Proposed Revisions to a Standard Plans Index

Originator:	Gibbs, Shae	Index Number:	711-001
Date:	9/17/24	Sheet Number(s):	4
E-mail:	shae.gibbs@dot.state.fl.us	Index Title:	Pavement Markings

~~BUFFERED EXPRESS LANE STRIPING~~

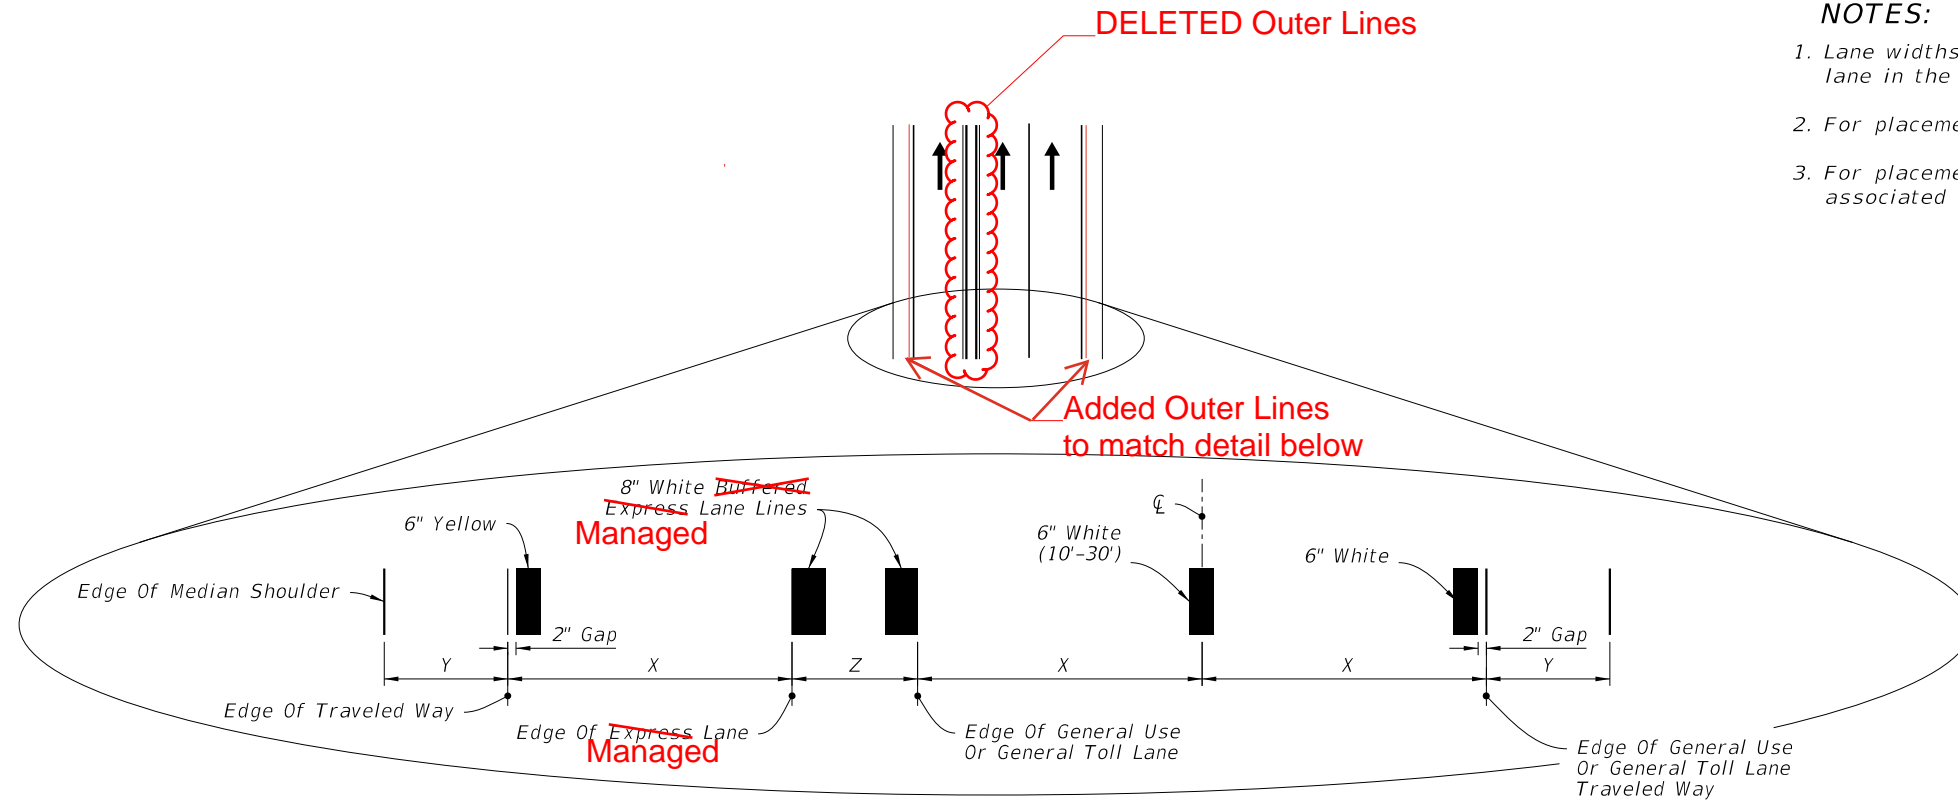
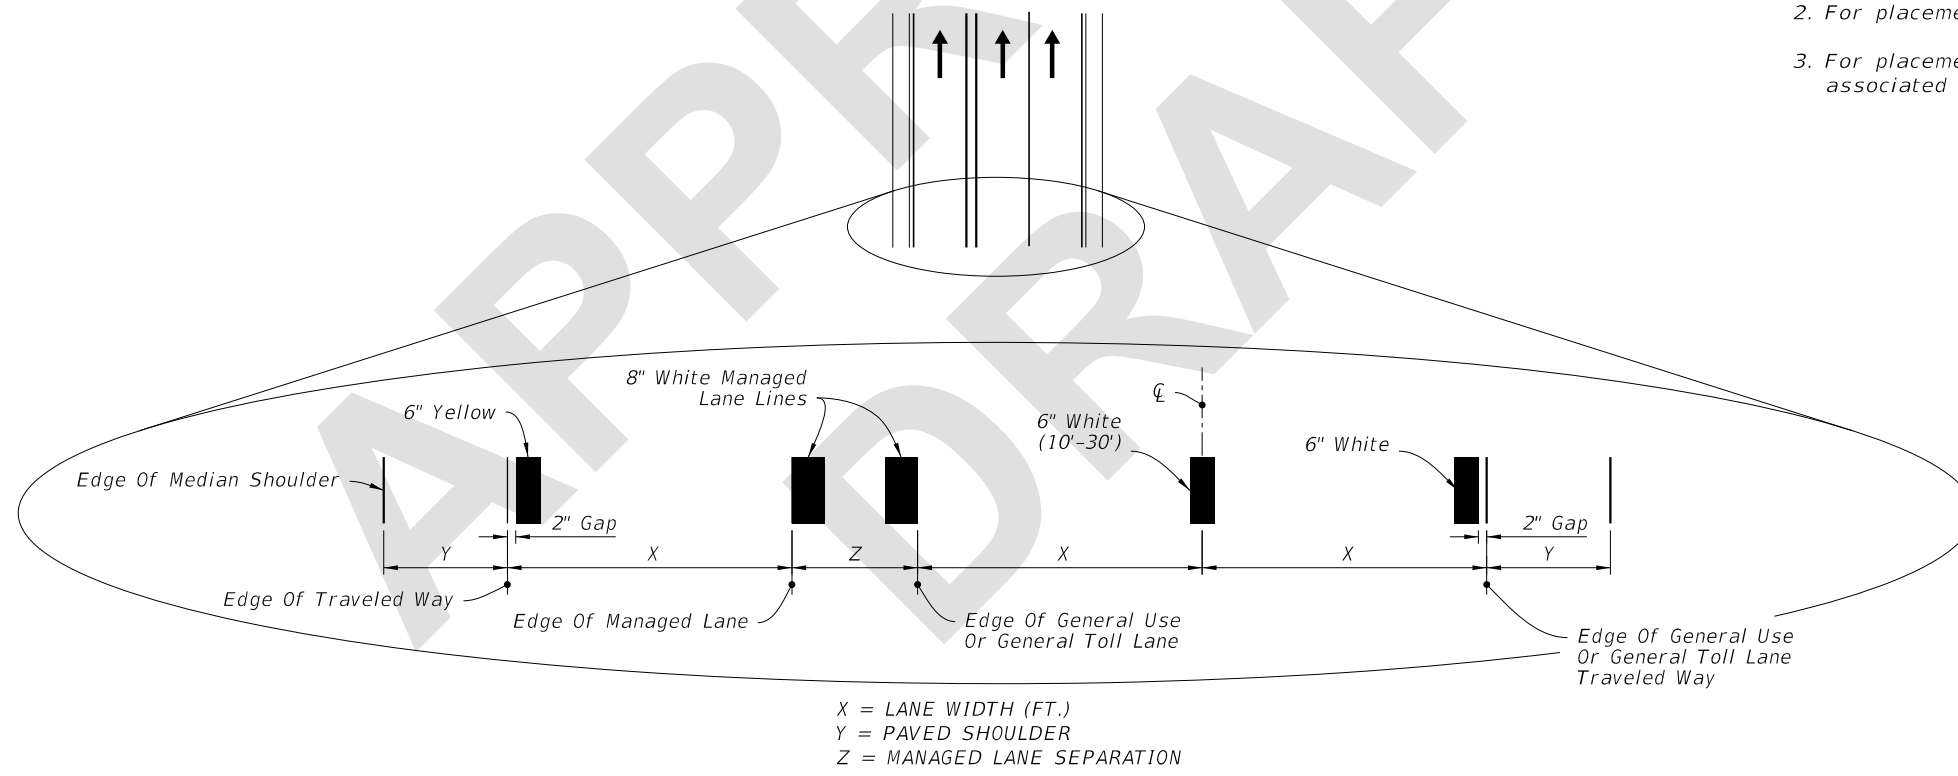
Sheet 4: Updated Buffered Express Lane Striping Detail to replace "Express" with "Managed" in title and callouts; Deleted "Buffered" in detail title and callout; Replaced "Buffer" with "Separation" in callout; Deleted extraneous lines from the detail; Updated Note 3 to replace "Express Lane" with "Tubular"

1. Lane widths (X) may not be same for each lane in the section.
2. For placement of RPMs, see Index 706-001.
3. For placement of ~~Express Lane~~ **Tubular** markers and associated RPMs, see the Plans.

1. Lane widths (X) may not be same for each lane in the section.
2. For placement of RPMs, see Index 706-001.
3. For placement of tubular markers and associated RPMs, see the Plans.

MANAGED LANE STRIPING
